15.2.0 SAFETY LIMITS AND LIMITING SAFETY SYSTEM SETTINGS

Point Beach Nuclear Plant
Core Operating Limits Report

Unit 1, Cycle 23
Unit 2, Cycle 22

Figure 15.2.1-1
REACTOR CORE SAFETY LIMITS
POINT BEACH UNIT 1

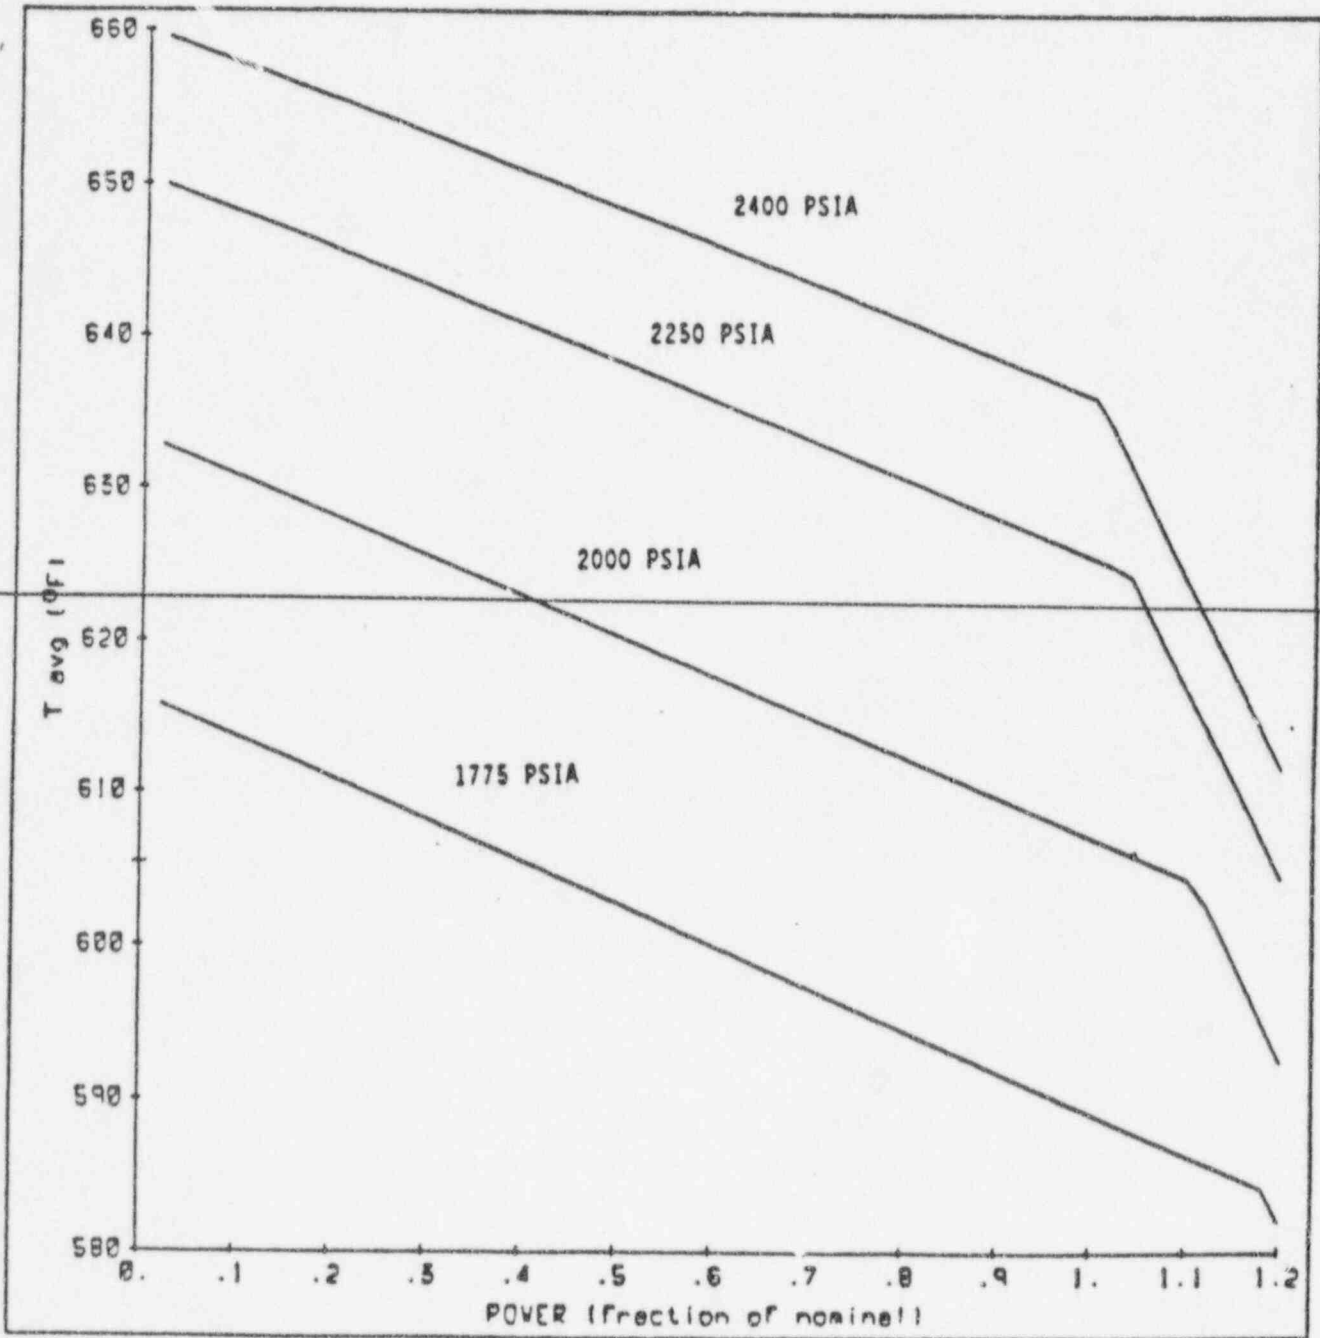
1. ~~The combination of thermal power level, coolant pressure, and coolant temperature shall not exceed the limits shown in Figure 15.2.1-1 for Unit 1 and Figure 15.2.1-2 for Unit 2. The safety limit is exceeded if the point defined by the combination of reactor coolant system average temperature and power level is at any time above the appropriate pressure line. During power operation, the departure from nucleate boiling ratio (DNBR) shall be maintained ≥ 1.17 for the WRB-1 DNB correlation.~~
2. During power operation, the peak fuel centerline temperature shall be maintained $< 5080^{\circ}\text{F}$, decreasing by 58°F per 10,000 MWD/MTJ of burnup.

~~The curves of Figure 15.2.1-1 and 15.2.1-2 are applicable for a core of 14 x 14 OFA. The curves also apply to the reinsertion of previously depleted 14 x 14 standard fuel assemblies into an OFA core. The use of these assemblies is justified by a cycle specific reload analysis. The WRB 1 correlation is used to generate these curves. Uncertainties in plant parameters and DNB correlation predictions are statistically convoluted to obtain a DNBR uncertainty factor. This DNBR uncertainty factor establishes a value of design limit DNBR. This value of design limit DNBR is shown to be met in plant safety analyses, using values of input parameters considered at their nominal values.~~

With normal axial power distribution, the reactor trip limit, with allowance for errors⁽²⁾, is always below the reactor core safety limits ~~as shown on Figure 15.2.1.1 for Unit 1 and Figure 15.2.1.2 for Unit 2.~~ If axial peaks are greater than design, as indicated by the difference between top and bottom power range nuclear detectors, the reactor trip limit is automatically reduced⁽⁶⁾⁽⁷⁾.

The overpower, overtemperature and pressurizer pressure system setpoints include the effect of reduced system pressure operation (including the effects of fuel densification). The setpoints will not exceed the core safety limits ~~as shown in Figure 15.2.1.1 for Unit 1 and Figure 15.2.1.2 for Unit 2.~~

FIGURE 15.3.10-1

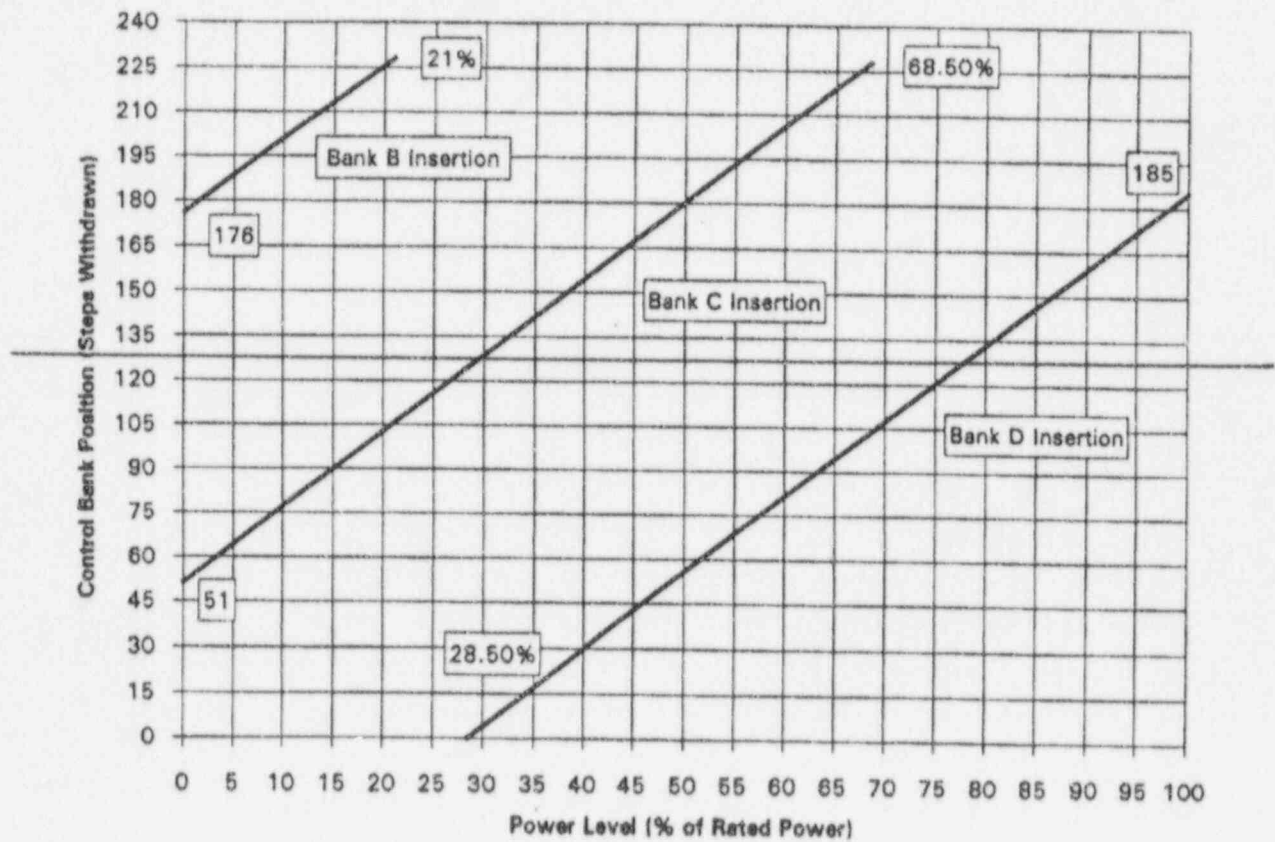
2. ~~When the reactor is critical, the control banks shall be inserted no further than the limits shown by the lines on Figure 15.3.10-1. Exceptions to the insertion limit are permitted for physics tests and control rod exercises.⁽¹⁾ The control banks shall be within the limits specified in the COLR.~~

When the insertion limits specified in the COLR are observed ~~and the control rod banks are above the solid lines shown on Figure 15.3.10-1,~~ the shutdown requirement is met. The maximum shutdown margin requirement occurs at end of core life and is based on the value used in analysis of the hypothetical steam break accident.

2. Control rod banks are sequenced with overlapping banks as described in ~~Figure 15.3.10-1~~ the COLR.
3. The full-length control bank insertion limits are not violated.

- 2.4.1 When the reactor is critical, the control banks shall be inserted no further than the limits shown by the lines on Figure 2. Exceptions to the insertion limit are permitted for physics tests and control rod exercises. Fully withdrawn is defined as a bank demand position equal to or greater than 225 steps.

FIGURE 15.3.10-2
REQUIRED SHUTDOWN MARGIN

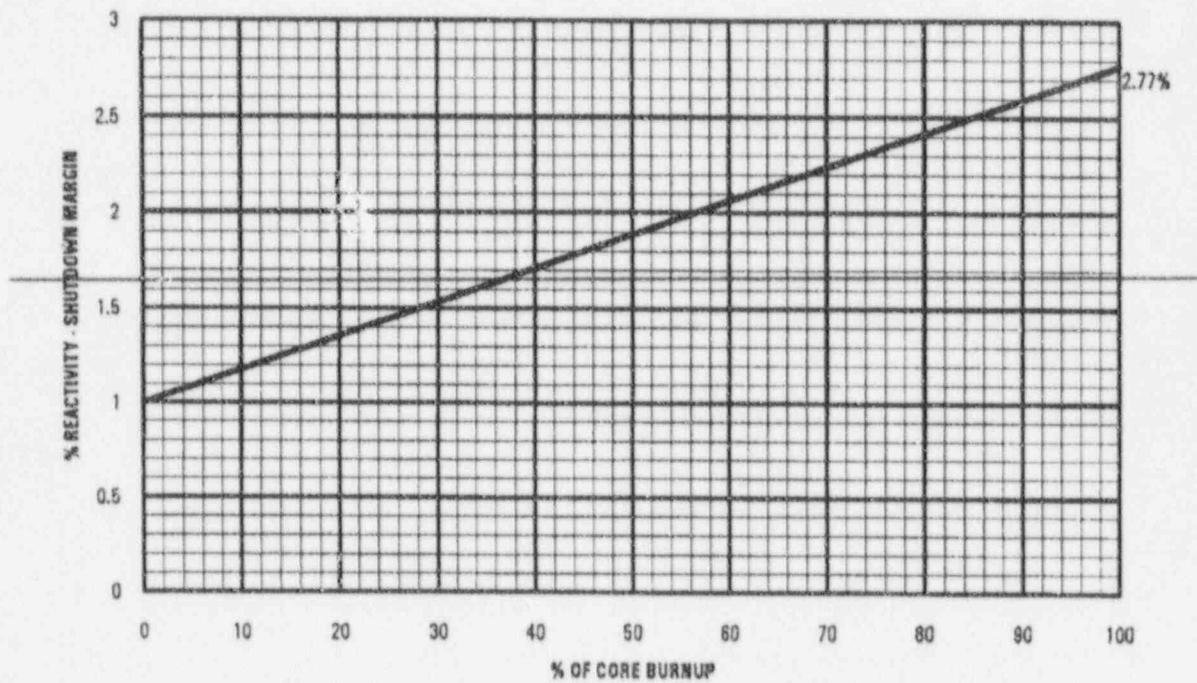
3. ~~The shutdown margin shall exceed the applicable value as shown in Figure 15.3.10-2 under all steady state operating conditions from 350°F to full power. An exception to the stuck RCCA component of the shutdown margin requirement is permitted for physics tests. be within the limits specified in the COLR.~~

Figure 15.3.10-2 As shown in the COLR, shows the shutdown margin is equivalent to 2.77% reactivity at end-of-life with respect to an uncontrolled cooldown. All other accident analyses assume 1% or greater reactivity shutdown margin. Shutdown margin calculations include the effects of axial power distribution. One may assume no change in core poisoning due to xenon, samarium or soluble boron.

- 2.1.1 The shutdown margin shall exceed the applicable value as shown in Figure 1 under all steady-state operating conditions from 350°F to full power. An exception to the stuck RCCA component of the shutdown margin requirement is permitted for physics tests.
- 2.1.2 Except for physics tests, a shutdown margin of at least 1% $\Delta k/k$ shall be maintained when the reactor coolant temperature is less than 350°F.

FIGURE 15.3.10-3

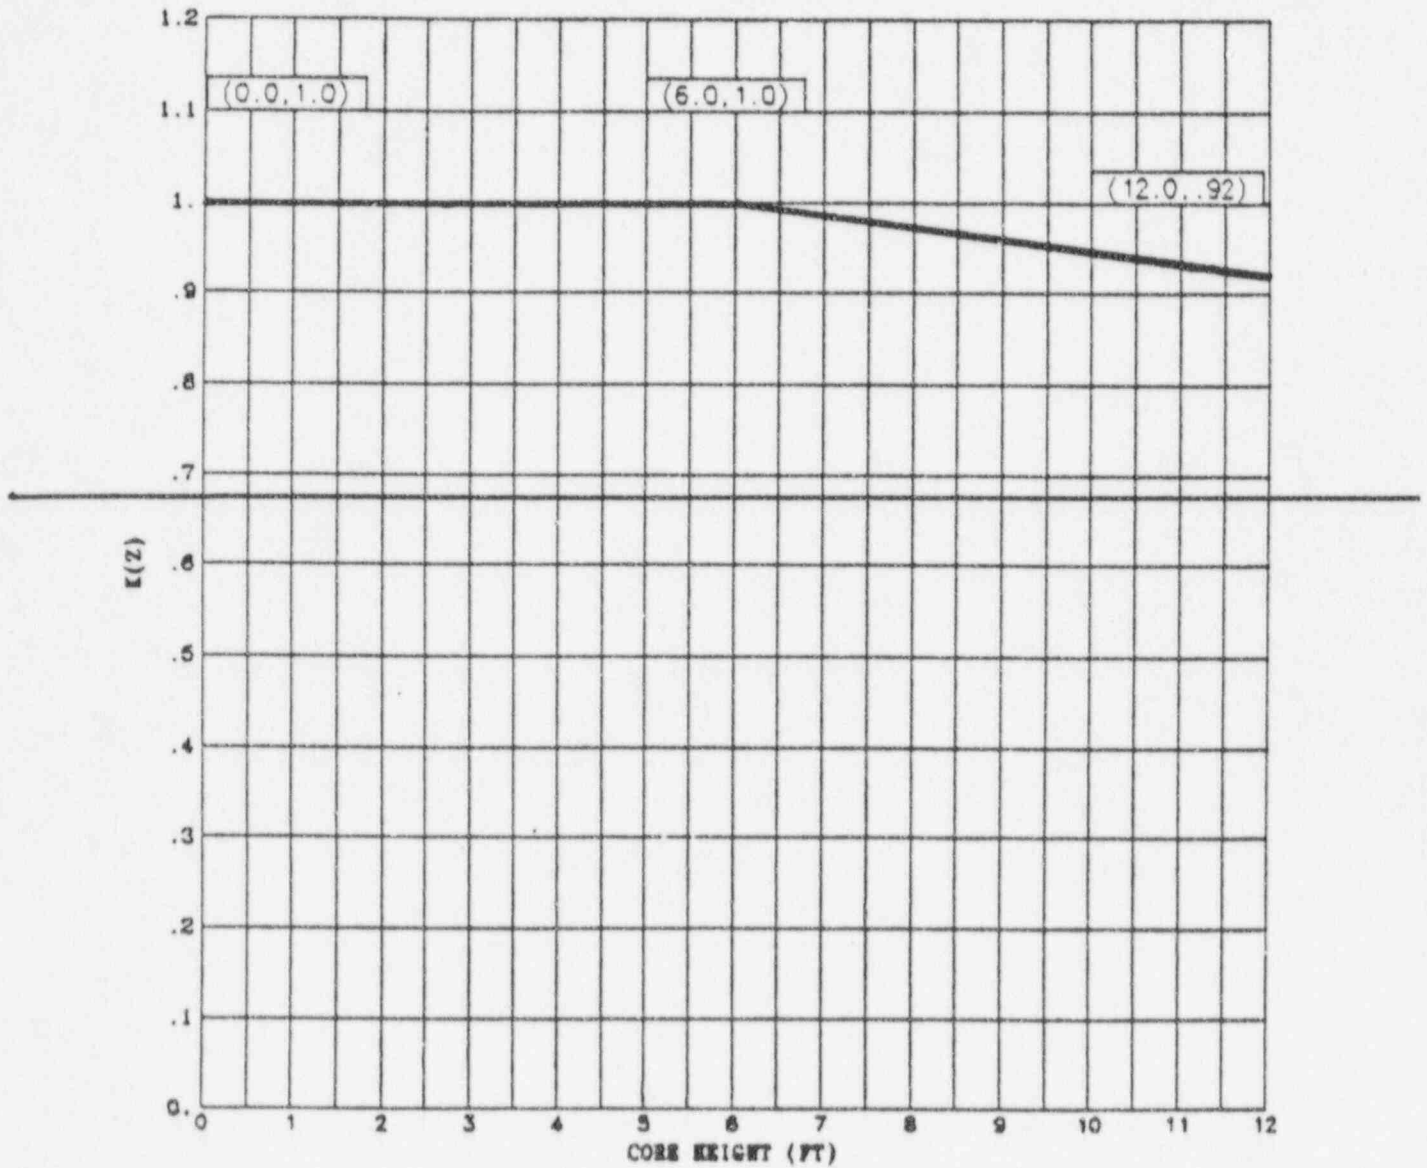
~~Where P is the fraction of full power at which the core is operating, K(Z) is the function in Figure 15.3.10.3 and Z is the core height location of F_Q .~~

An upper bound envelope of ~~2.50 times the normalized peaking factor axial dependence of Figure 15.3.10-3~~ (specified in the COLR) consistent with the Technical Specifications on power distribution control as given in Section 15.3.10 was used in the large and small break LOCA analyses. The envelope was determined based on allowable power density distributions at full power restricted to axial flux difference (ΔI) values consistent with those in Specification 15.3.10.B.2. The results of the analyses based on this upper bound envelope indicate a peak clad temperature of less than the 2200°F limit. When an F_Q measurement is taken, both experimental error and manufacturing tolerance must be allowed for. Five percent is the appropriate allowance for a full core map taken with the moveable incore detector flux mapping system and three percent is the appropriate allowance for manufacturing tolerance. In the design limit of $F_{\Delta H}^N$, there is eight percent allowance for uncertainties which means that normal operation of the core is expected to result in a design $F_{\Delta H}^N \leq 1.70/1.08$. The logic behind the larger uncertainty in this case is that (a) normal perturbations in the radial power shape (i.e., rod misalignment) affect $F_{\Delta H}^N$, in most cases without necessarily affecting F_Q , (b) while the operator has a direct influence on F_Q through movement of rods, and can limit it to the desired value, he has no direct control over $F_{\Delta H}^N$ and (c) an error in the predictions for radial power shape which may be detected during startup physics tests can be compensated for in F_Q by tighter axial control; but compensation for $F_{\Delta H}^N$ is less readily available. When a measurement of $F_{\Delta H}^N$ is taken, experimental error must be allowed for and four percent is the appropriate allowance for a full core map taken with the moveable incore detector flux mapping system.

$K(Z)$ is the function in Figure 3, and

FIGURE 15.3.10-4

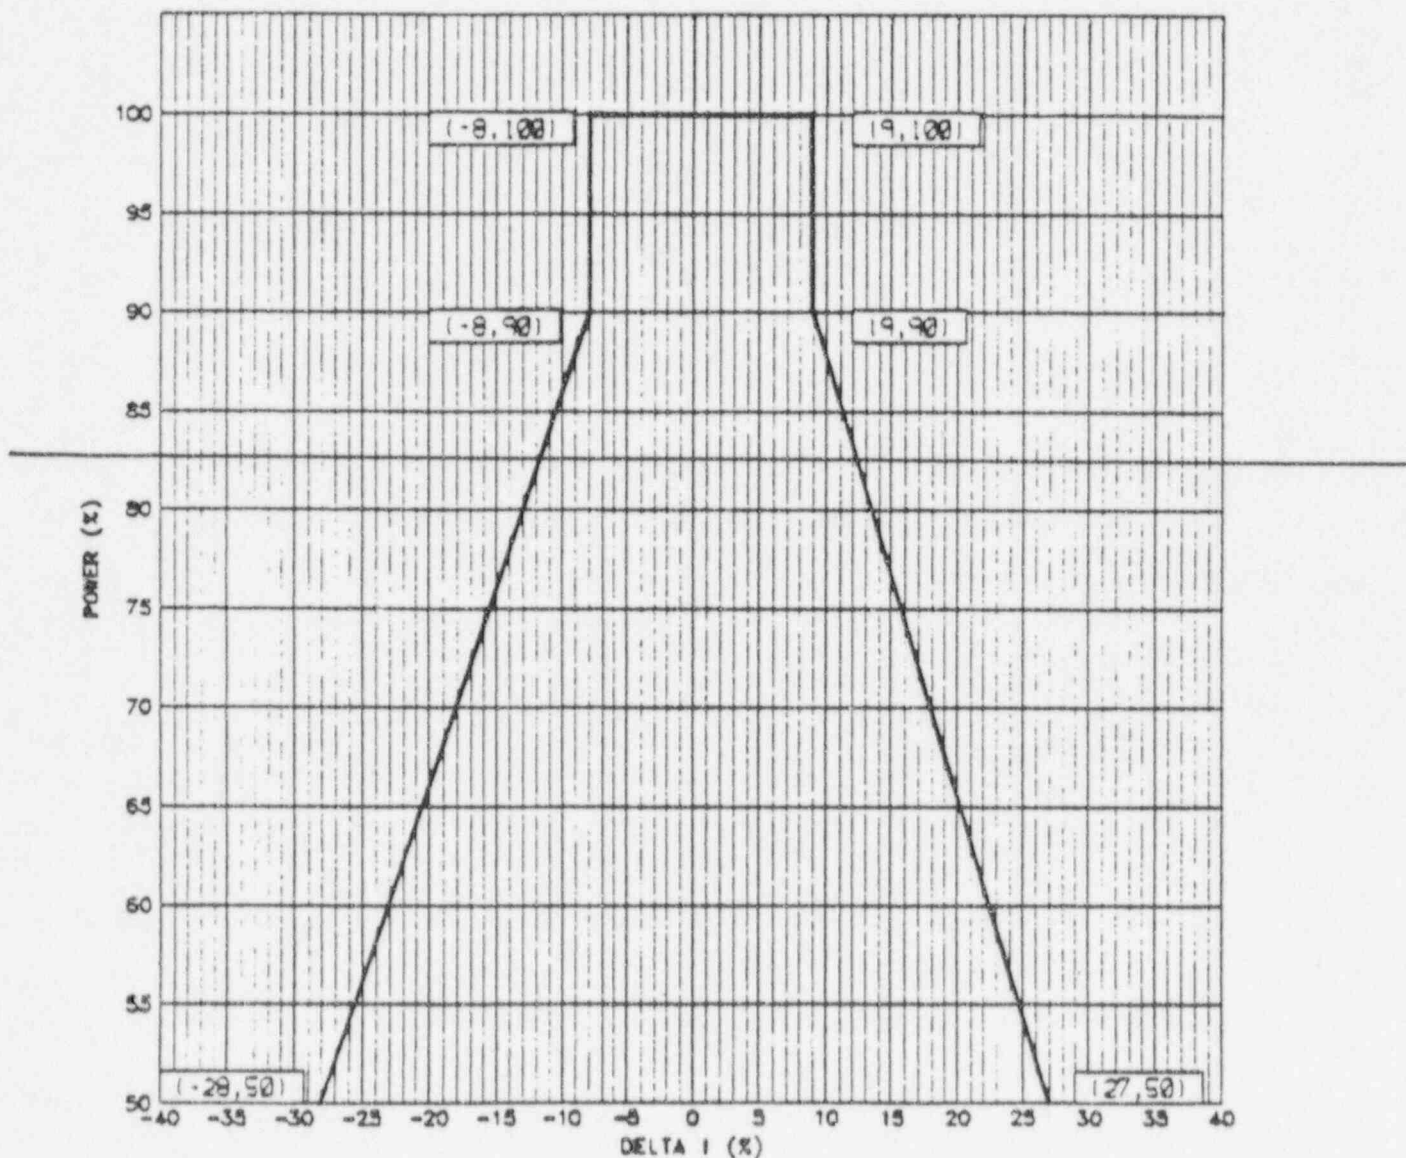
2. a. The indicated axial flux difference (AFD) shall be maintained within the ~~allowed operational space defined by Figure 15.3.10-4~~ limits specified in the COLR except during physics tests. The physics test exemption applies provided that the thermal power is less than or equal to 85% of Rated Power and the limits of Specification 15.3.10.B.1.a are satisfied. During suspension of the specification, the thermal power shall be determined to be less than or equal to 85% of rated thermal power at least once per hour. In addition, the surveillance requirements of 15.3.10.B.1.b shall be performed at least once per 12 hours.

- b. If the indicated AFD deviates from the ~~Figure 15.3.10-4 limits~~ requirements of 15.3.10.B.2.a, the AFD shall be restored to within the ~~Figure 15.3.10-4 limits~~ requirements of 15.3.10.B.2.a within 15 minutes. If this cannot be accomplished, then reactor power shall be reduced until the AFD is within the envelope or the power level is less than 50 percent of Rated Power. Normally the rate of power reduction is 15% per hour. Once AFD has been returned to and maintained within the operating envelope, power level is no longer restricted. If it is necessary to reduce power to 50%, the Power Range Neutron Flux-High Trip Setpoints shall be reduced to less than or equal to 55 percent within the next 4 hours.

- c. A power increase to a level greater than 50 percent of Rated Power is contingent upon the indicated AFD being within the ~~Figure 15.3.10-4 limits~~ requirements of 15.3.10.B.2.a.

- 2.6.1 The indicated axial flux difference shall be maintained within the allowed operational space defined by Figure 4 except during physics tests.
